ASHBURTON DISTRICT COUNCIL - INSPECTION CHECK

PROJECT LOCATION: 268 Moore Street

PROJECT DESCRIPTION: Erect 3 detached townhouses

Re: Your building consent application no. 980149
Erect 3 detatched townhouses.
268 MOORE ST

LOCATION!	DRAWN: MITCH VAN DER KROGT.	SITE PLAN	SIZE: 1012 m²
DATE:			SCALE: 1:100

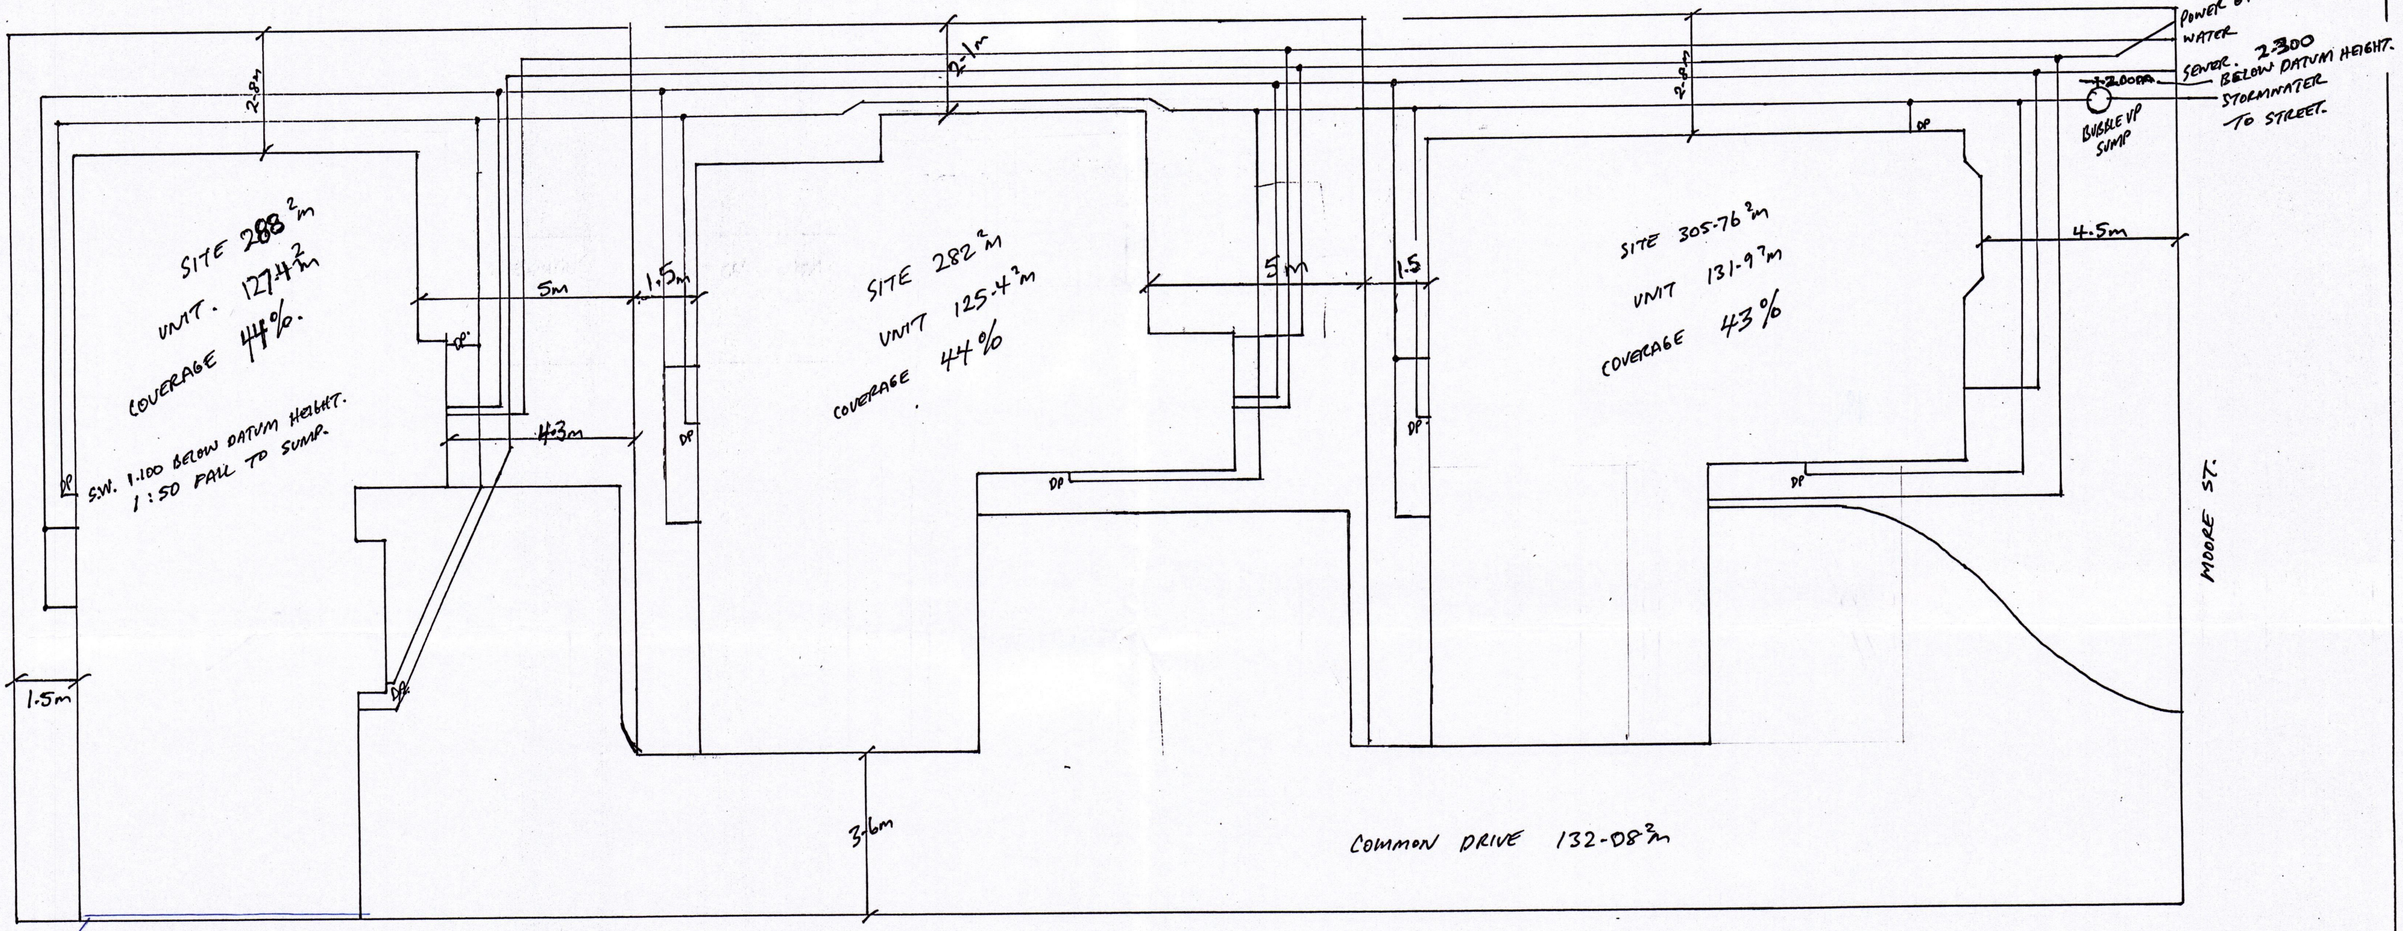
- Show spouting on fire wall [must not be over adjacent property].
- Specifications required for:
  i drain under building
  ii ventilation to toilet front unit.

(1) Show spouting on fire wall [must not be over adjacent property]

Town Planning UNIT 1
(a) Zoning Residential
(b) Siting ~~ok~~ NOT OK - 1.5 M SETBACK REQ'D [illegible] UNIT 1, UNIT 2.
(c) Resource Consent required (~~Yes~~/No)?
(d) Site coverage ok.
(e) Landscaping —
(f) Recession planes ok.
(g) Loading areas, etc —
(h) Outdoor living space ok
(i) Outdoor service space ok
(j) Carparking ok
(k) Other? —

NEW PLANS ALL OK ~~[illegible]~~ 19/03/98

NOTE: SPOUTING NOT TO OVERHANG ON ADJACENT PROPERTY.
